REMARKS

This is in response to the Final Office Action mailed March 5, 2004, in which the Examiner rejected claims 1, 2, 4, 5, 7, 8, 10, 11, 17, 18, 20, 22 and 23. Reconsideration of the application as amended is respectfully requested.

FIG. 4

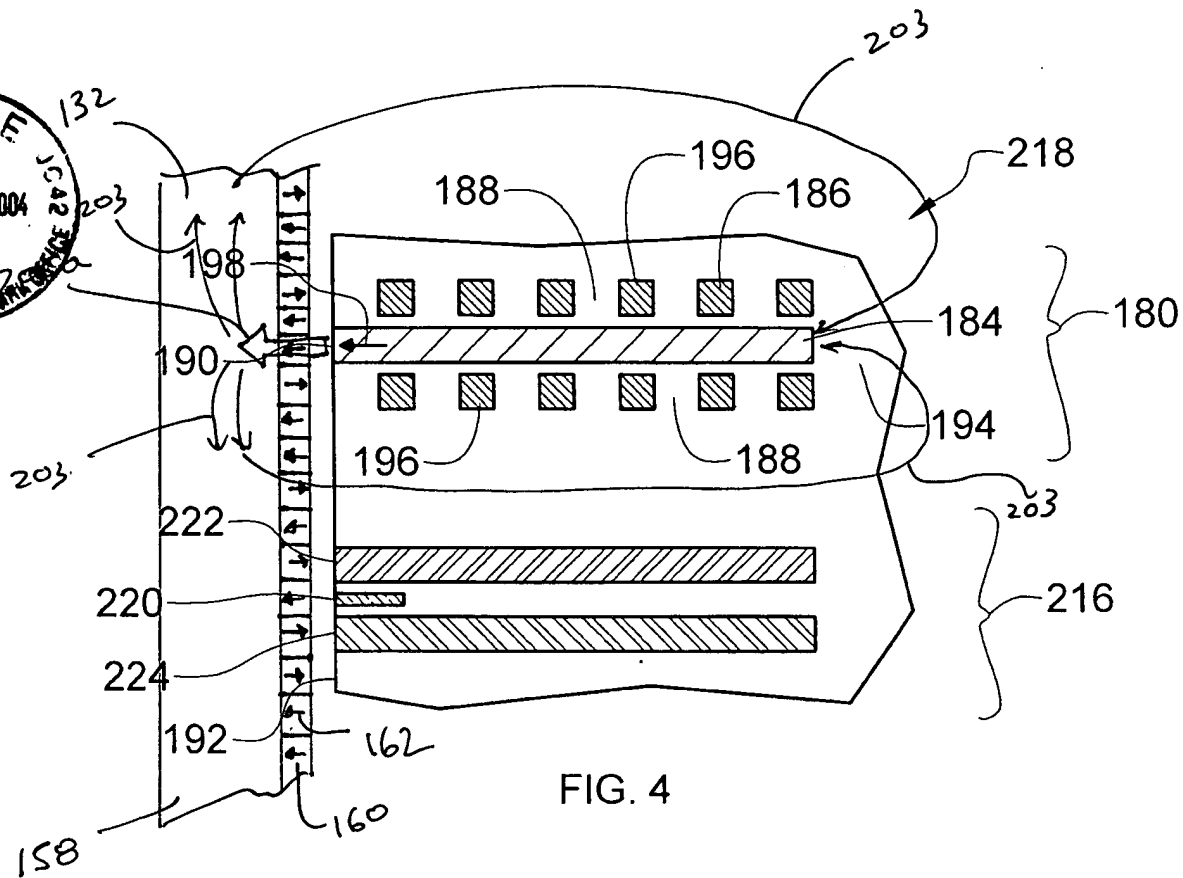
In Section 1 of the Office Action, the Examiner objected to FIGS. 4 and 5, but provided no indication as to the authority for the rejections. Even so, Applicant has submitted proposed corrections to FIGS. 4 and 5 that include the requested elements in an effort to expedite the prosecution of the present application. Should the Examiner still find grounds to object to the drawings, Applicant requests that the Examiner specify with particularity the authority (e.g., 37 C.F.R. §1.81, 1.83 or 1.84), on which the rejections are based.

Examiner has based the rejections on a finding of a need to depict additional flux lines in order to more thoroughly describe the operability of the claimed write element. In general, the Examiner fails to assert that the claimed write element will not operate as described.

For example, the Examiner wonders where the flux goes and "how is flux prevented from interacting with the MR element shields in such a manner that one or both shields act as a return path?" Applicant believes that there may be some misunderstanding of the term "conducted". In order to have a return path that "conducts" the magnetic signals to the writing pole at the back gap region, a link of magnetically conductive material (i.e., a return pole) must be attached to the writing pole at the back gap region where the magnetic signals can be returned to the writing pole. An example of such a return pole is shown in FIGS. 2 and 3 as return pole 140, which, as best shown in FIG. 2, is attached to the writing pole 144 at the back gap by a back gap via 148.

As claimed and clearly provided with reference to FIGS. 4 and 5 and explained in the corresponding written description, the writing elements 180 and 182 of the present invention lack such a magnetically conductive return path. Instead, writing pole 184 is insulated from such connections by insulating material 188. Accordingly, the shields 222 and 224 of the read element 220 of the present invention cannot act as a magnetically conductive return path to the writing pole 184 at the back gap region 194 since they are not connected to the writing pole 184 by a link of magnetically conductive material.

Although Applicant respectfully believes that the rejections are improper since the Examiner has failed to establish a reasonable basis for questioning the enablement of the present application, Applicant has provided herewith proposed drawing corrections to FIGS. 4 and 5 to provide the requested flux lines and a corresponding replacement sheet, in an effort to expedite the prosecution of the present application. Additionally, amendments to the specification have been made to explain the newly depicted elements in the drawings.
